Service Bulletin

Bulletin No.: PIC6026

Subject: Unable To Connect High Voltage Cable To Replacement Accessory DC Power Control Module (APM)

Models: 2011-2013 Chevrolet Volt

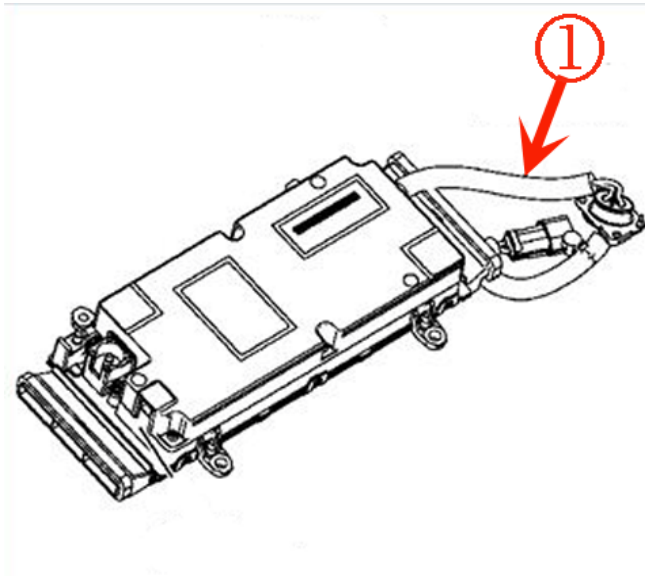
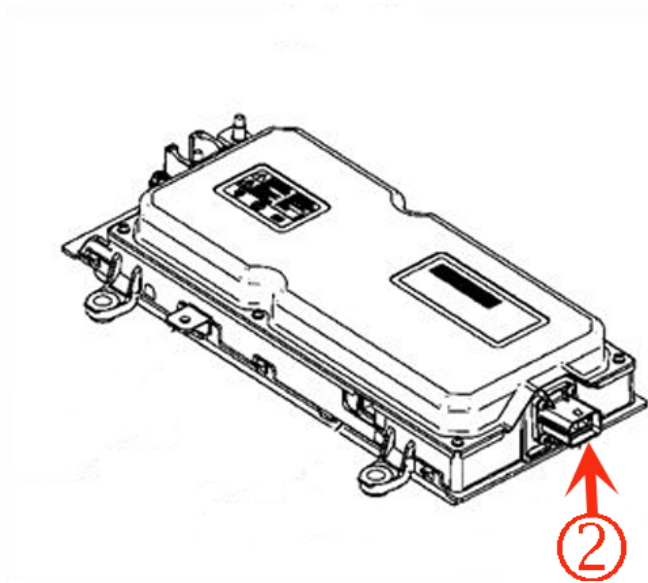
Certain 2011-2013 Chevrolet Volts were equipped with a first design APM which has a 24 inch orange pigtail attached to the module and there is no high voltage connection right at the module itself (See Photo Below)

When replacing the APM with a new service part APM, you will notice that the new part has no pigtail and the high voltage connection is right at the module itself (See Photo Below)

If your vehicle has a first design module and you are replacing the APM , an additional jumper harness (GM Part Number 24268507) will need to be installed. An instruction sheet will be provided with the jumper harness kit on how to install the new design module. If the jumper harness instructions were not included with the new part, please contact the Technical Assistance Center for a copy of the instruction sheet.
